This is the ~~second~~third posting of the proposed revisions to the standard in accordance with Results-Based Criteria and the fifth draft overall.

FAC-003-2 — Transmission Vegetation Management

Figure 1

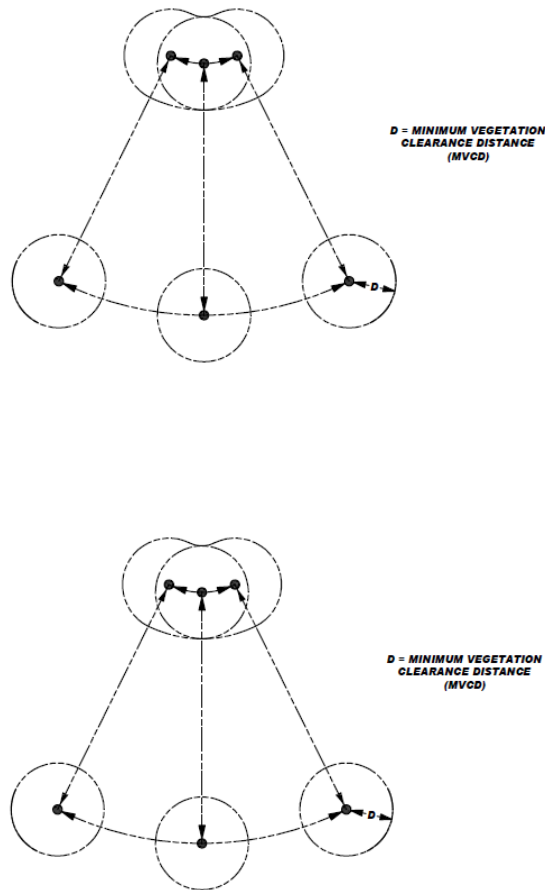
The conductor's position in space at any point in time is continuously changing as a reaction to a number of different loading variables. Changes in vertical and horizontal conductor positioning are the result of thermal and physical loads applied to the line. Thermal loading is a function of line current and the combination of numerous variables influencing ambient heat dissipation including wind velocity/direction, ambient air temperature and precipitation. Physical loading applied to the conductor affects sag and sway by combining physical factors such as ice and wind loading. The movement of the transmission line conductor and the MVCD is illustrated in Figure 1 below.

Cross-section view of a single conductor at a given point along the span showing six possible conductor positions due to movement resulting from thermal and mechanical loading.
